BEFORE THE HEARING BOARD OF THE SAN LUIS OBISPO COUNTY  
AIR POLLUTION CONTROL DISTRICT  
STATE OF CALIFORNIA

Case No. 17-01

**PETITION TO MODIFY EXISTING  
STIPULATED ORDER OF  
ABATEMENT AND/OR ISSUE A NEW  
ORDER OF ABATEMENT**

**SUBJECT: SAG response to 15 October Draft 2019 Annual Report and Work Plan (ARWP) for Oceano Dunes SVRA produced by the California Department of Parks and Recreation OMHVR Division in Response to Stipulated Order of Abatement Number 17-01.**

# Exhibit 9

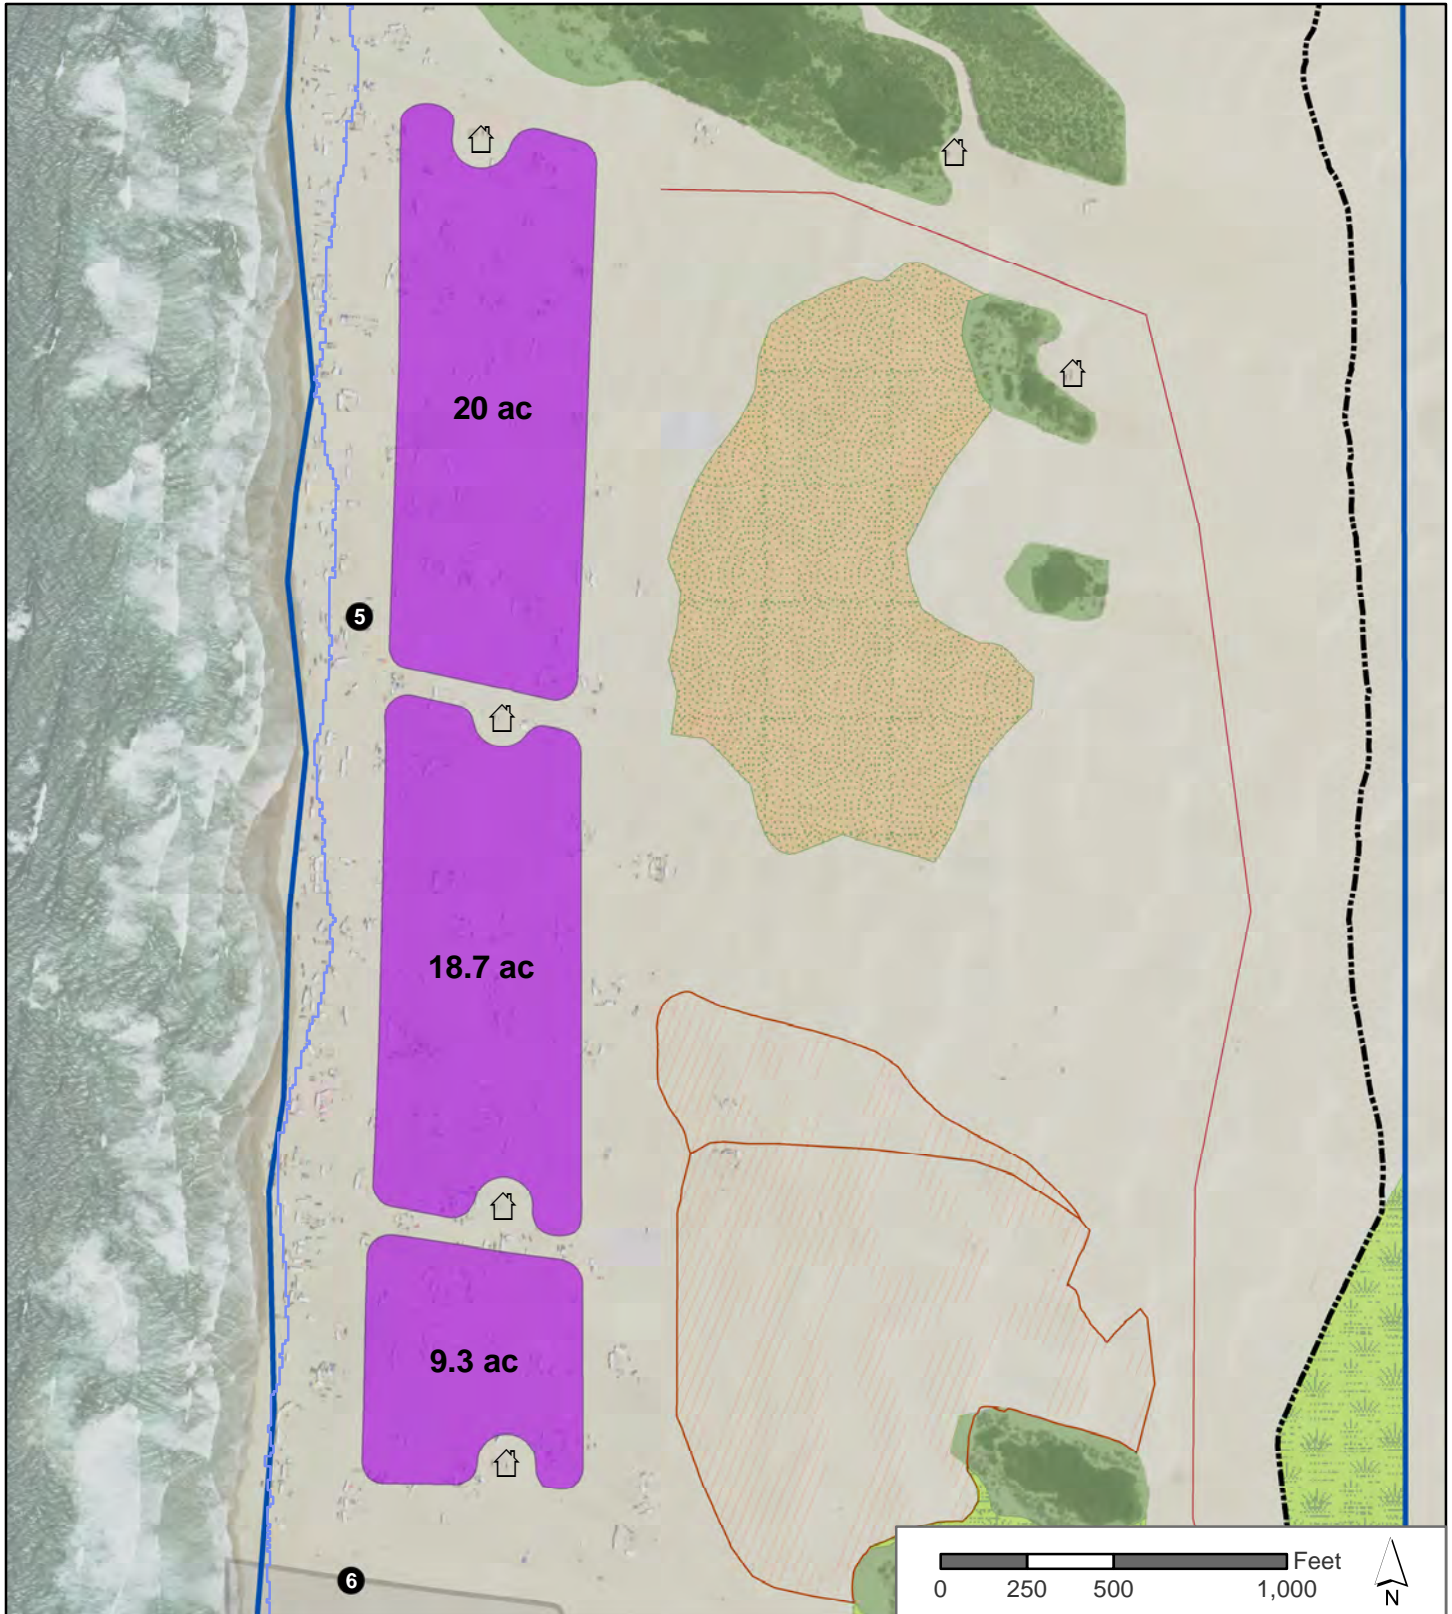
6 a. Complete installation of perimeter fencing for the 48-acre vegetated foredune  
7 project described in Section 3.1.6 of the Third Draft Work Plan, and shown in its Exhibit 9, by  
8 January 1, 2020, with the planting of native vegetation begun by April 1, 2020. Table 5-5 of  
9 the Third Draft Work Plan shall be updated to reflect these deadlines. With regard to the  
10 CEQA and Coastal Commission approvals discussed in Section 3.1.6 and Table 5-5 of the  
11 Third Draft Work Plan, Respondent shall work as expeditiously as possible to obtain those  
12 approvals. Until the foredune project is approved by the California Coastal Commission and  
13 mitigation measures are fully implemented, non-motorized public access to the vegetated  
14 foredune proposed project area may be permitted as long as plantings are protected, but off-  
15 highway vehicle activity and camping is prohibited after January 1, 2020.

1. OHMVR Division shall include in the ARWP an explicit plan to exclose, permit, and implement the full 48-acre foredune restoration zone immediately.
2. The 2019 ARWP "Implementation Schedule" (Sec. 5) shall include a table specifying a detailed process for SAG consultation and evaluation, including submission of interim reports and work plans (IRWPs) as follow-on updates to the 2019 ARWP. This table shall include the following tasks and schedules for completion:
